## All Thunder Tiger Raptors 30 & 60 size

### RAPTOR BLADE MODIFICATION

(AMENDED Feb. 22, 2002)

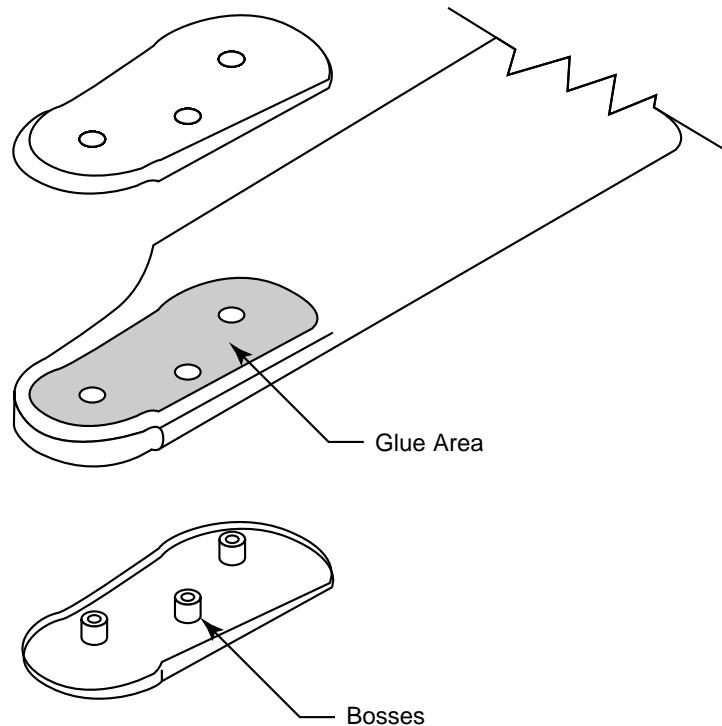
1. Mark around blade grips with a felt-tip marker.
2. Remove blade grips and cut covering lightly .125" inside of mark, being careful not to cut into blade.
3. Repeat for opposite side.
4. Trim bosses if necessary to allow tight fit on the blades.
5. Lightly sand inside of grips for better adhesion. Apply included epoxy to blades in area shown top and bottom. Be generous with the application to ensure a strong bond.
6. Attach blade grips and tighten screws.
7. Wipe off excess epoxy.
